CITY OF HAYWARD AGENDA REPORT

Zone Change Application No. PL-2005-0301 PD – Request to Amend the Prezoning District Designation from Medium Density Residential (RM) to Planned Development (PD), to Allow for Construction of 149 Single-Family Homes, and to Approve the Associated Preliminary Development Plan

Vesting Tentative Map Tract Application No. PL-2005-0303 TTM 7657 - Request To Subdivide an Approximately 12.5-Acre Site to Create 149 Single-Family Lots and Related Streets

ZONE CHANGE APPLICATION NO. PL-2005-0301 PD KB HOME – MT. EDEN DEVELOPMENT

Plan 2 Elevations

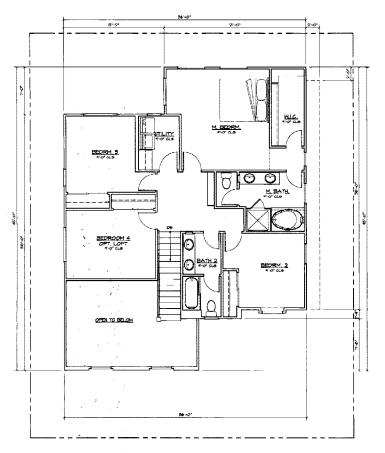
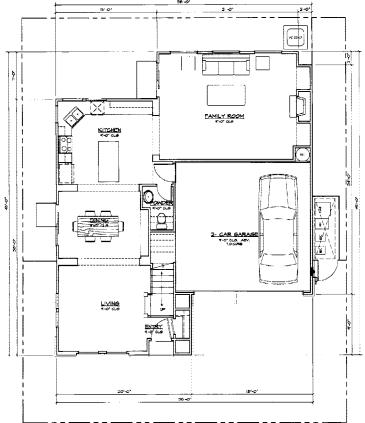
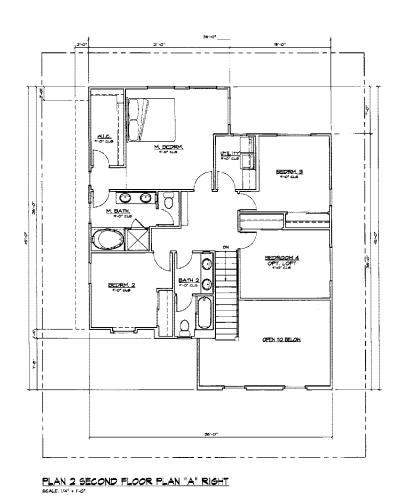
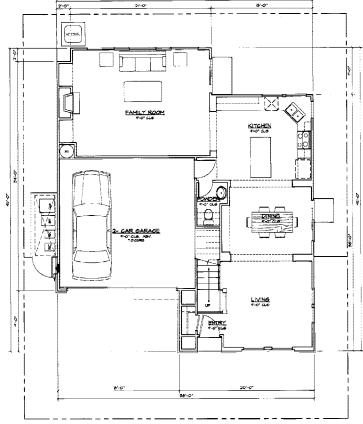
- iv. Greater architectural relief shall be provided to the front elevations of Plan 6 and Plan 2 (Tuscan).

PLAN 7 FRONT ELEVATION 'D', SPANISH SCALE: 1/4" = 1"-0"

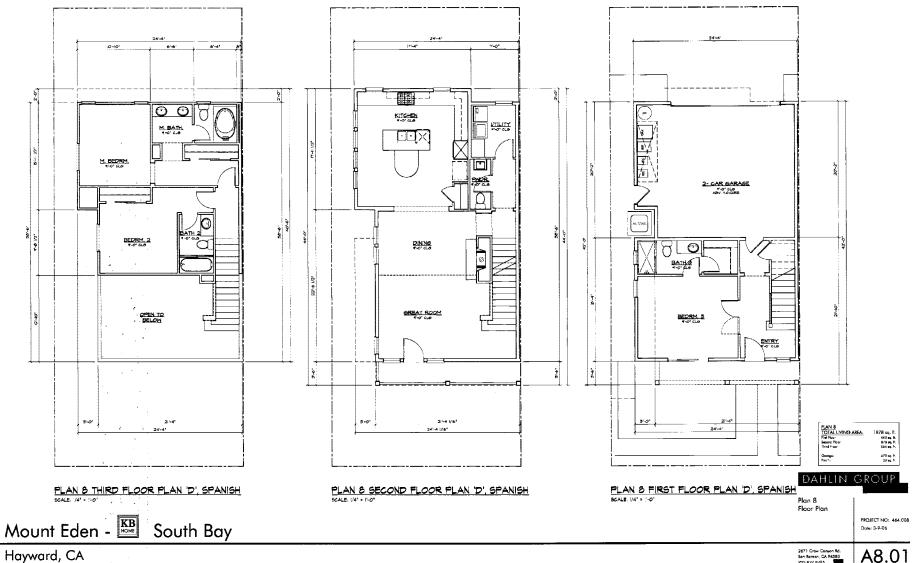
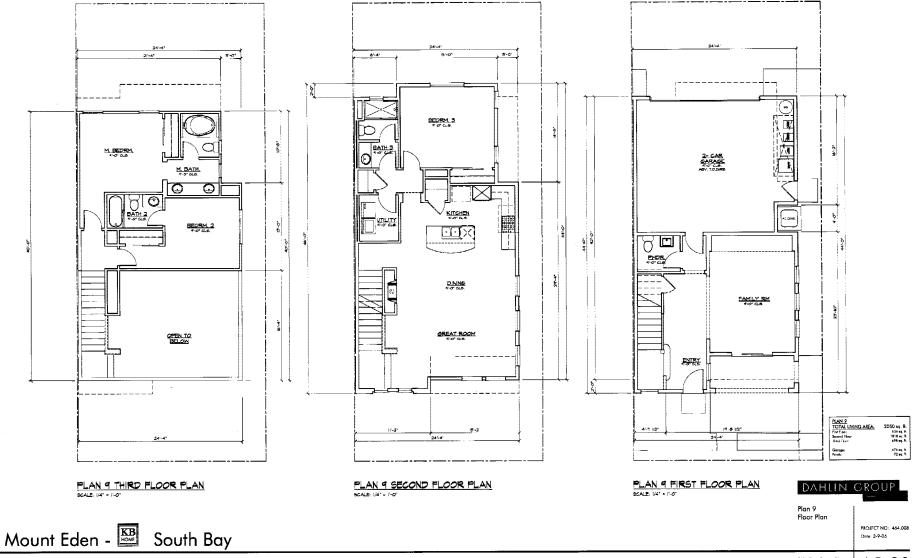
- v. Plan 7 shall also include a Tuscan style.
- vi. The front door entry of Plan 4 shall be architecturally enhanced.
- vii. Provide details of architectural elements, such as grille work, and porches and window and door trim.

- ix. Where secondary entry doors face public or private streets, glass door must be decorative and multi-paned (e.g.. French doors).
- x. On Plan 7 (duets), create greater individuality between units by offsetting them, providing privacy barriers between entries, changing color shades, etc.

TYPICAL ALLEY LOADED PLAN
MT. EDEN (DUTRA PROPERTIES)

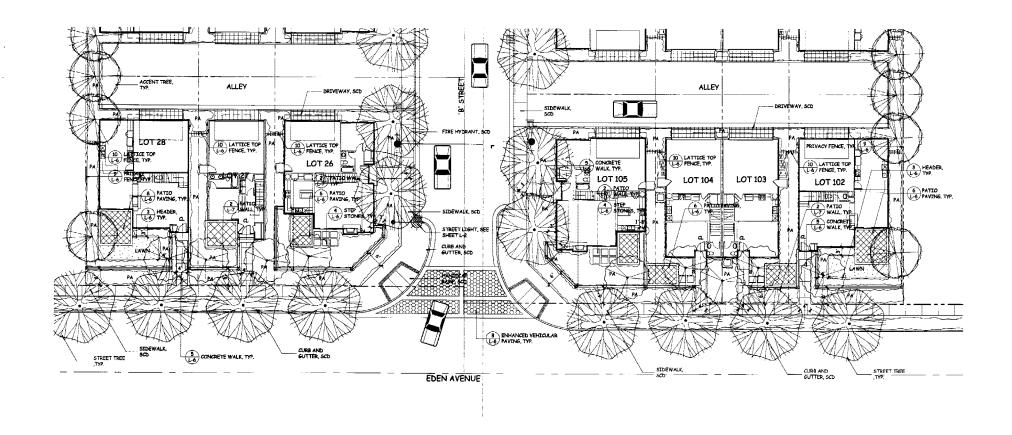
- u. Show all site utilities, including cable, water meter and other above-grade utility boxes, on 'Typical Frontage and Alley Loaded Landscape Plan' and provide landscape design that is coordinated with civil grading and drainage plan and utilities plan. Trees shall be planted a minimum of five feet from all utilities. When conflict occurs, relocation of utilities shall be studied before eliminating trees or planting areas.
